Certified Action of the City of Raleigh Planning Commission

Case File / Name: SP-25-11 / Cameron Place Condominiums

SUBJECT: SP-25-11 / Cameron Place Condominiums

Staff Report

SP-25-11 – Cameron Place Condominiums – Preliminary Site Plan

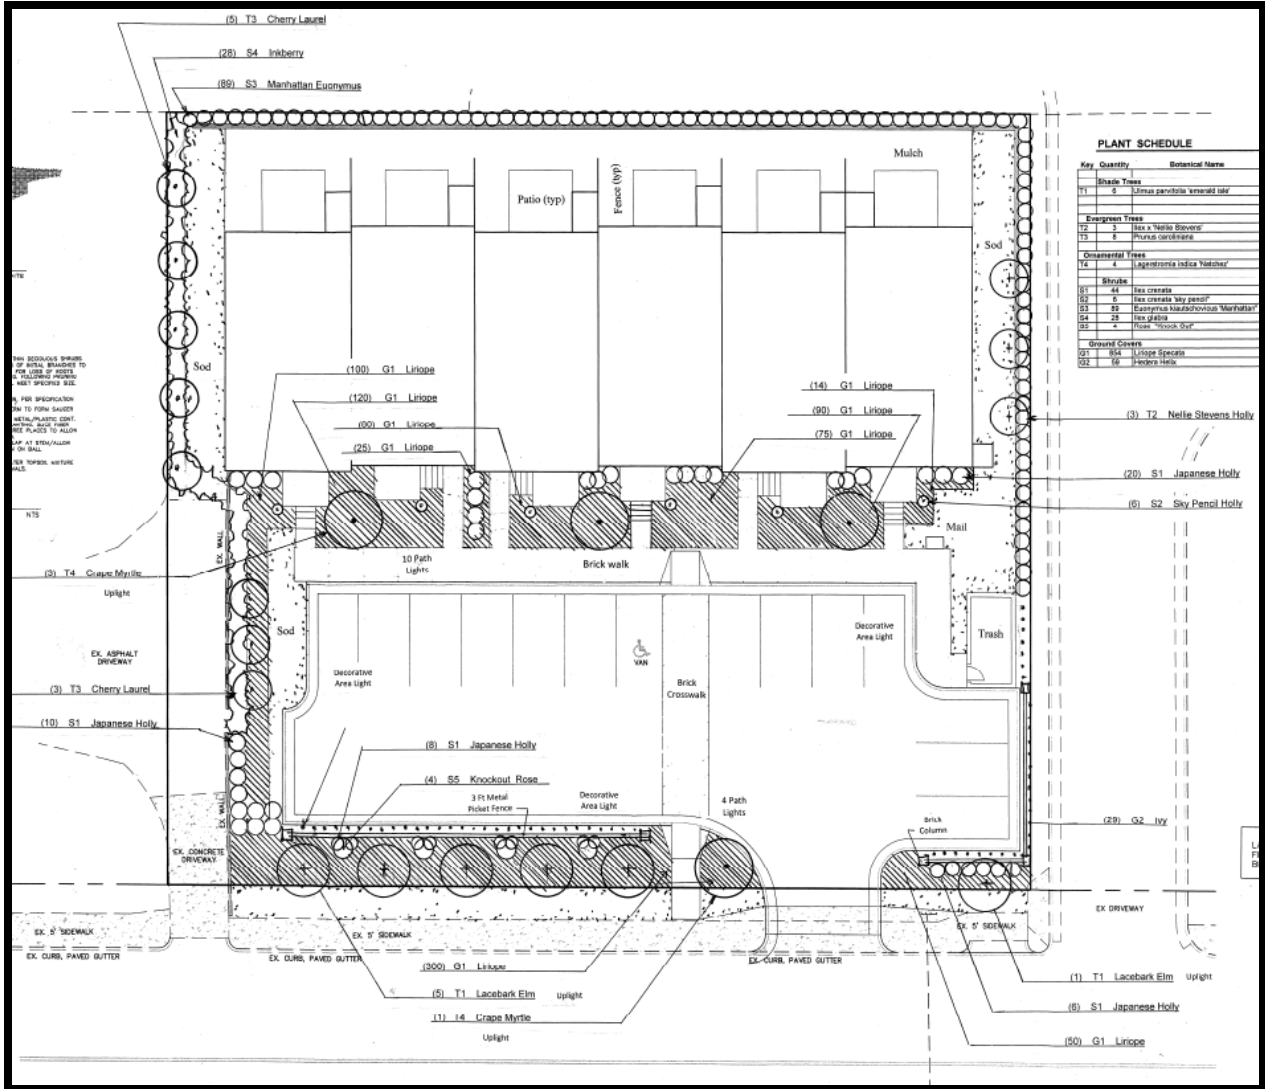
- (1) That for the drain pipe system proposed across the parking lot to the southwest, the developer must demonstrate:
 - (a) how diffused flow will be achieved,
 - (b) how the proposed flow does not cross over a sidewalk ,and
 - (c) how gutter spread requirements are being met at this location;

<u>Comment</u>	<u>Response</u>
<p>The proposed site plan represents a departure from both present neighborhood character and the City's urban design goals. The committee recommends that at the very least, the placement of the building and parking lot be reversed, such that parking is removed from the front yard, and the building directly addresses the street [commensurate with Code Sec. 10-2132.2(d)(1), (2), (3), (4), (5), and (6)]. This recommendation is based upon the following observations:</p> <ul style="list-style-type: none"> ▪ The proposed parking lot placement introduces an unwarranted design element to this section of Daniels Street. Nearby properties predominantly feature wide green space in their front yards. Even the adjacent Cameron Village Condominium complex, which does include a series of pull-in parking spaces next to the street (halfway within the right-of-way), is characterized by a continuous lawn area dotted by mature trees, with all its other parking spaces located behind the buildings. The latter configuration is also characteristic of the subject site, with the added aspect of several very large shade trees providing visual and environmental relief from hardscape areas. ▪ The parking lot location contradicts the notion of redevelopment in the Cameron Village area favoring pedestrian travel. The single sidewalk connection proposed in the plan directs residents to circumnavigate the parking lot, meeting the existing street sidewalk at the frontage point furthest from the shopping/mixed use center. ▪ Pushing the buildings to the 	<p>The present neighborhood character is predominantly suburban and dominated by 130 unit Cameron Village Condominiums on the west side of Daniels Street and the single family subdivision, Cameron Park on the east side of Daniels Street. Both were developed years ago and are not likely to be redeveloped into a more urban form in the foreseeable future. The location of buildings and parking in Cameron Village Condominiums are varied. Our site plan is within the range of this general character. There are few if any sites that will come up for redevelopment in the near future. Parking in the front on this small half-acre site will not set the precedent for potential redevelopment of Cameron Village Condo site at some point many years in the future.</p> <p>Parking in the front of a town home with the private outdoor space in rear is a proven relationship marketable with buyers. The public realm, pedestrian activities, connection to the street and views are oriented to the east toward Daniels Street, Cameron Village and toward downtown. Less desirable elements related to the adjacent office building will be screened from private patios with fencing and landscaping.</p> <p>Placing the parking in the rear of town homes creates a number of unique problems:</p> <ol style="list-style-type: none"> (1) The number of homes built would be reduced. Therefore the price must be either raised, the design standards lowered, the town home size reduced to maintain the price point or change to the stacked flat that requires less ground area and private outdoor space is not expected. (2) Parking not visible from public areas creates real or perceived safety issue. (3) Access into the town home is from the rear. (4) There is little or no private outside living space.

rear of the property renders them more proximate to noise, light, and odor from the utility areas, mechanical equipment, and parking lots on the non-residential properties immediately adjacent to the west.

- The proposed front yard parking potentially sets a precedent for future redevelopment in the neighborhood.

Along the open-picket fence fronting the parking area, intersperse evergreen shrubs with the proposed roses [commensurate with Code Sec. 10-2132.2(d)(2), (3) & (4)].

Provide added pedestrian pathway lighting leading from the street (e.g., uprights on the proposed elms) [commensurate with Code Sec. 10-2132.2(d)(1)].

We responded positively to the second Appearance Commission meeting making the following changes as suggested. We improved the pedestrian access to street and the shopping center by creating a central brick cross walk from the sidewalk adjacent to the town homes through the parking area to the sidewalk at Daniels Street.

- 1) Additional planting adjacent to Daniels Street.
- 2) Gate to trash enclosure was moved so as not to be seen from Daniels.
- 3) Cross sections developed to confirm that landscaping provides screening of parking lot.
- 4) Lighting plan including area lights, up lights and walkway lights.
- 5) Moved iron fence closer to parking curb allowing more landscaping on the street side.
- 6) Added hollies around knock out roses to soften during winter.
- 7) Side and rear architectural elevations.

Revised as requested

Revised as requested
